Responses to reviewers - HESS manuscript egusphere-2025-1650

Reviewer 1:

Reviewer 2

Revised caption: Figure 7: For MSD intensity, the percent of total variance contributing to each source included in this analysis, for the base period of 1970-1999 (top row) and for different levels of global warming. Only grid cells exhibiting 50% or greater frequency of MSD years are colored.

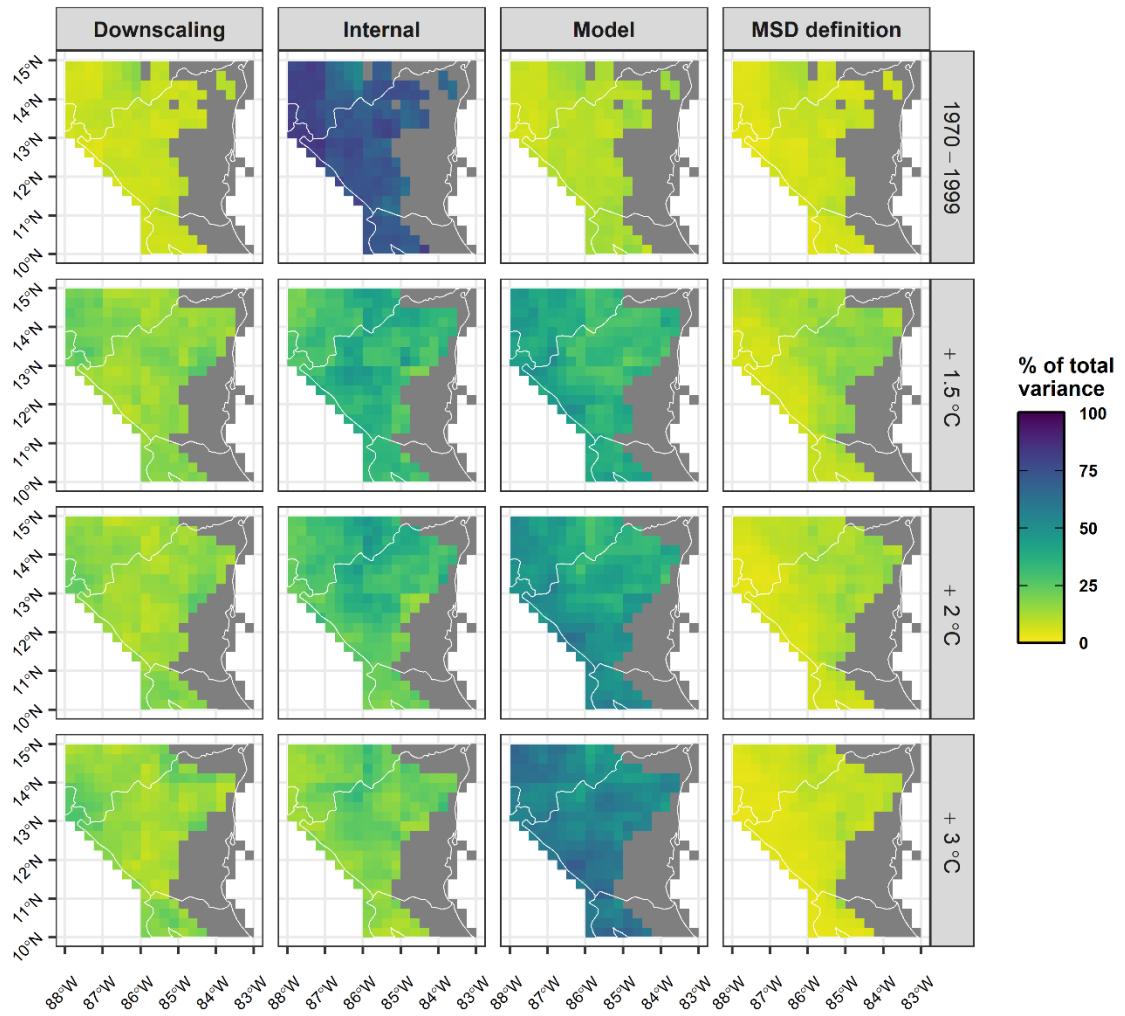
1. My main question concerns the apparent mismatch between Figures 4 & 5 and Figure 6. The distribution of white (meaning NULL) grid points in Figures 4 & 5 would suggest that the MSD definition has a considerable impact on its frequency and spatial extent, yet this doesn't show in the variance decomposition results of Figure 7. As I understand, the variance decomposition results for intensity and duration are conditional on the MSD occurring since the authors drop all NULL values, but I wonder whether a frequency-based metric might show qualitatively different patterns. As the authors are likely aware, frequency is commonly considered in tandem with intensity and duration, and often required to form a full understanding of impacts. Would the authors be able to repeat the analysis for a suitably-defined frequency metric? Or if not, sharpen the discussion of the apparent mismatch between Figures 4-5 and the decomposition results in Figure 7?

This observation highlights the difference between Figures 4 and 5 (and Figure 3), which each show a different part of the domain that has MSDs in $\geq 50\%$ of years, and Figure 7, which shows the variance partitioning for the entire domain, regardless of MSD frequency. We have revised the methods section to include the following (line 160):

Figure 7 has been revised as shown below.
